D. J.'S SUBDIVISION

APPLICATION NUMBER 4 DATE June 15, 2006

D.J.'S SUBDIVISION

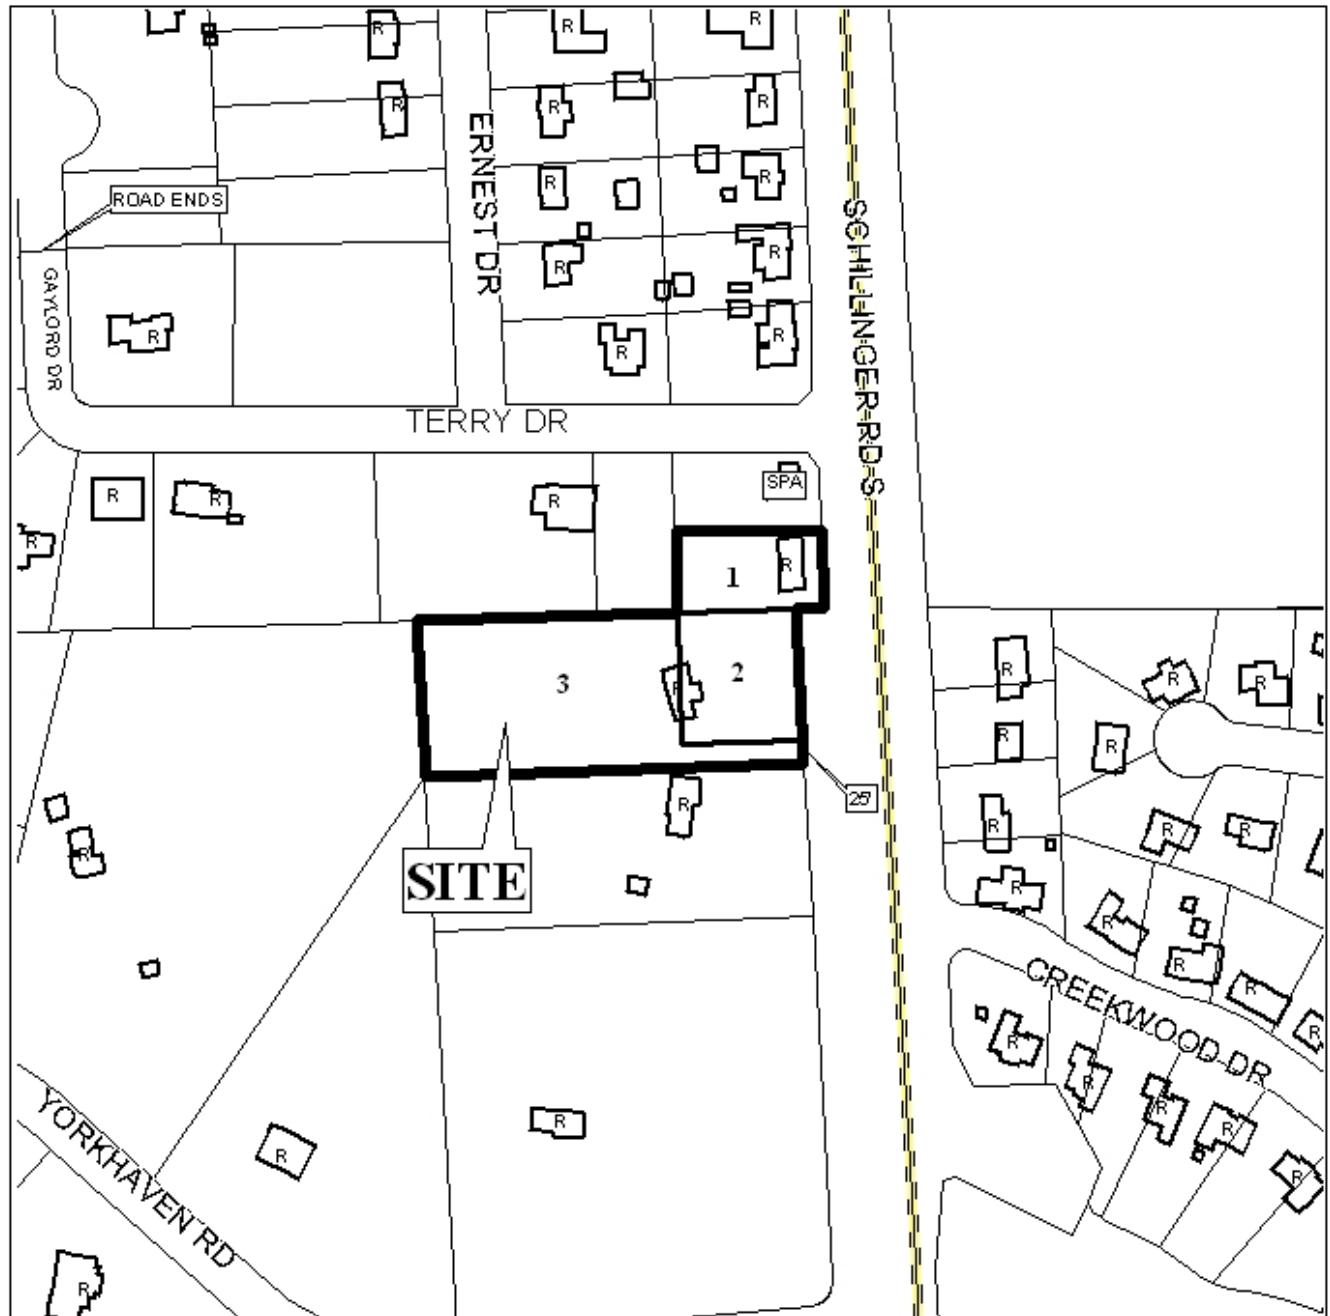
The purpose of the application is to create three lots of record from two existing lots. As shown, proposed Lot 1 would not change from its original configuration as a lot. The second original lot would be divided into a rectangular lot and a flag-shaped lot.

The site fronts Schillinger Road South, a planned major street with a 100-foot right-of-way along proposed Lot 1 and a 130-foot right-of-way along proposed Lots 2 and 3. As the Comprehensive Plan calls for a 100-foot right-of-way on Schillinger Road, no additional dedication would be required.

The surrounding area is characterized by very large-lot development, and the flag-shaped nature of proposed Lot 3 is uncharacteristic; thus it would not conform to Section V.D.1 of the Subdivision Regulations, which states: "*The size, width, depth, shape, and orientation of lots and the minimum building setbacks lines shall be appropriate to the location of the subdivision and the type of development and use contemplated.*"

Furthermore, the site is located on a major street, which would pose access management concerns, especially for a driveway that may be less visible without a corresponding structure. If the subdivision were allowed, a shared driveway would be strongly recommended.

A possible alternative would be a horizontal division of the property. This would require a waiver of the maximum depth requirement (Section V.D.3). However, from the street, the configuration would more closely resemble other smaller residentially developed lots to the North and across Schillinger Road.

The 25-foot setbacks are not shown but would be required on the final plat.

This application is recommended for Holdover to the July 20th meeting, to allow the applicant to submit revised drawings not showing flag-shaped lots. Revised materials should be received by June 19th to be considered.
